Item ID: D212-664-201

Item Name: Crosstube Aft

TO AMEND INSTRUCTIONS FOR CONTINUOUS AIRWORTHINESS ICA-D212-664 Rev. 6 OR LATER

DRAWING NO. D212-664-241	TITLE CROSSTUBE ASS'Y (205/212 HI AFT)	REV. D	DART AEROSPACE LTD ENGINEERING ORDER		D.E.O. NO. D212-664-241-D-2	SHEET NO. SHEET 1 OF 1	SCALE NTS
DRAWN 97	CHECKED ASS	MFG. APPR. [Signature]	APPROVED [Signature]		DE APPR. [Signature]		
DATE 11.07.15	DATE 11.07.20	DATE 11.07.21	DATE 11/27/21		DATE 11-07-21

FIGURE 1: SUPPORT INSTALLATION

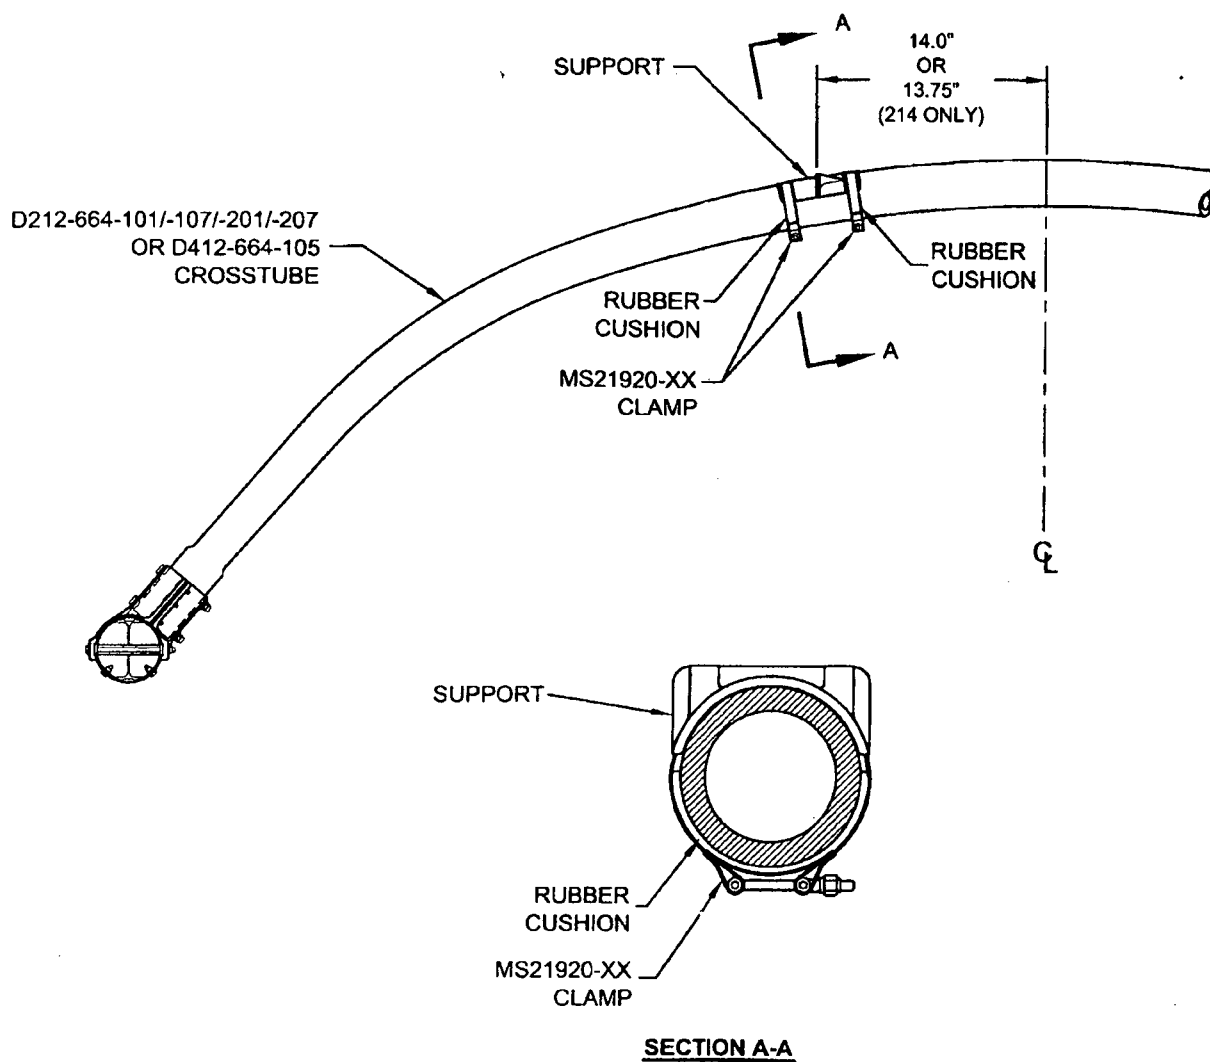
The supports on the following crosstubes are now installed using Proseal instead of Magnobond:

For the crosstubes listed above, section 32.4 of ICA-D212-664 is amended as follows. Use Figure 1 of this service instruction and Figures 32-2 to 32-9 of ICA-D212-664 for further reference. For crosstubes of an earlier change number, it is recommended that if the supports are removed, the supports should be reinstalled using the procedure listed below.

- 32.4.5 Apply a 0.04" to 0.07" thick layer of Proseal 890 Class B or AMS-S-8802 Class B sealant underneath applicable support and install support as shown in Figure 1 of this service instruction.

- 32.4.6 Install the clamps opposite to crosstube support as shown in section A-A of Figure 1. Install rubber cushions underneath each clamp around the bottom circumference of the crosstube up to the crosstube centerline. Torque clamps 80-100 in-lb (9.0-11.3 Nm). It is acceptable to use smaller or larger sized MS21920-XX clamps than those listed in ICA-D212-664, ensure that after torquing the clamps per this instruction, the nuts are in safety but not bottomed out

DART AEROSPACE LTD		Work Order:	92700
Description: Crosstube High Aft (205/212)		Part Number:	D212-664-201
Inspection Dwg: D212-664-241 Rev: D		Page 1 of 1

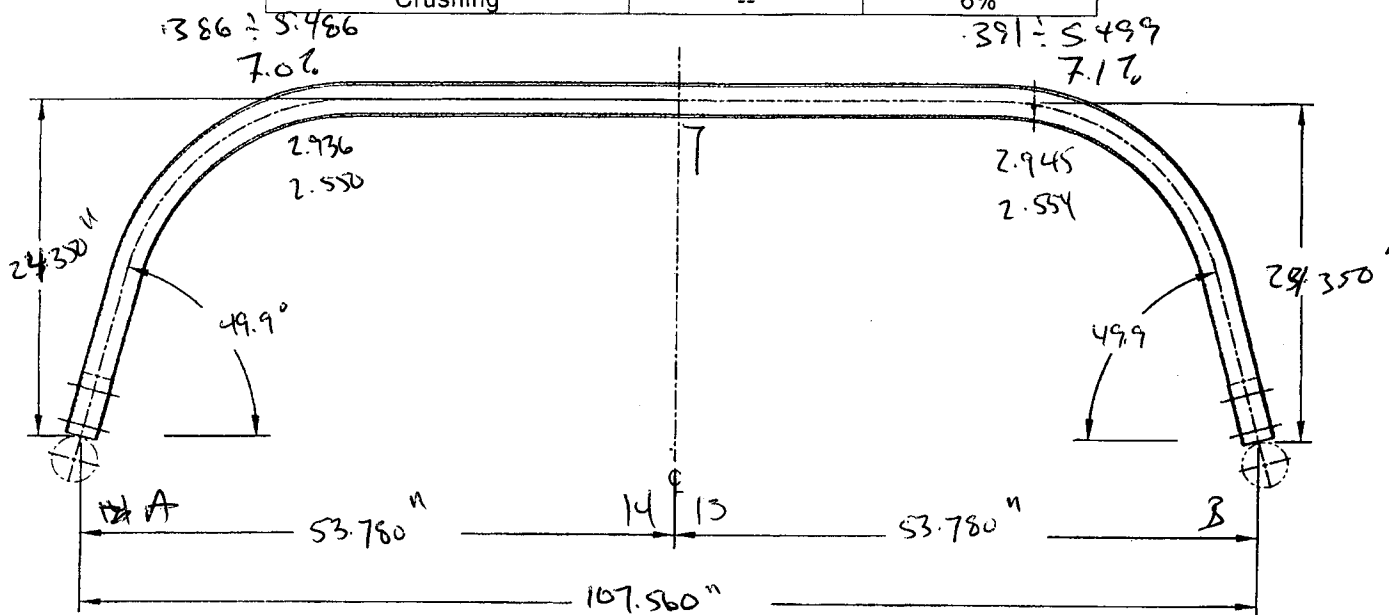
Side A	middle	Side B
Bending Passes	14	7	13
Crushing	7.06%		7.17%
Comments			
Side A = 7.06% crush @ 14 passes			
middle = 7 passes			
Side B = 7.17% crush @ 13 passes

D212-664-241/-241B
ASSEMBLY DETAIL

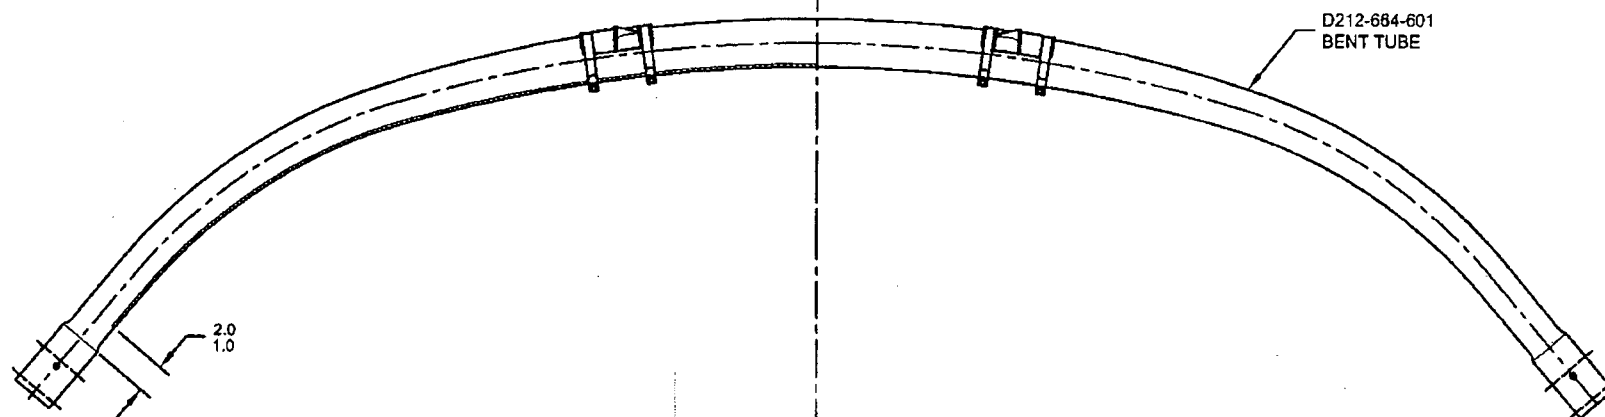
ADD AN INSPECTION WINDOW TO UNDERSIDE OF CROSSTUBE.

- 2) FINISH: CHEMICAL CONVERSION COAT PER DART QSI 005 4.1
PRIME INSIDE AND OUTSIDE PER DART QSI 005 4.2
MASK UNDERSIDE OF CROSSTUBE AS SHOWN (HATCHED AREA) AND
PAINT OUTSIDE PER DART QSI 005 4.2
REMOVE MASKING AND APPLY CLEAR COAT

MASK AREA PRIOR TO PAINTING,
REMOVE MASKING AFTER PAINT
AND APPLY CLEAR COAT

CRUSHING OF D212-664-201

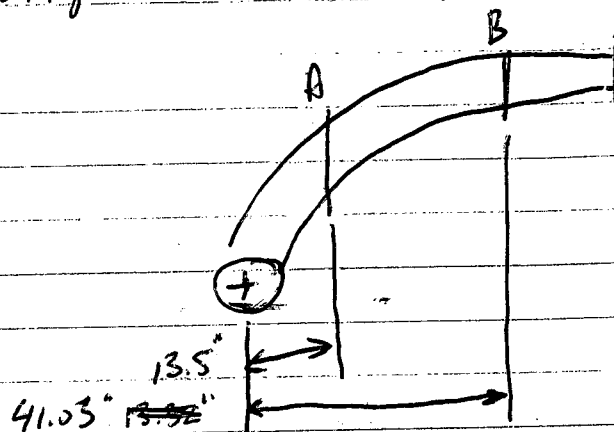
Acceptability of 8% CRUSHING

Point A: $OD1 = 2.548 \text{ in}$ $OD2 = 2.992 \text{ in}$
 $\text{CRUSHING} = (2.992 - 2.548) / (2.992 + 2.548) = 8\%$
 $I = 1.476 \text{ in}^4$
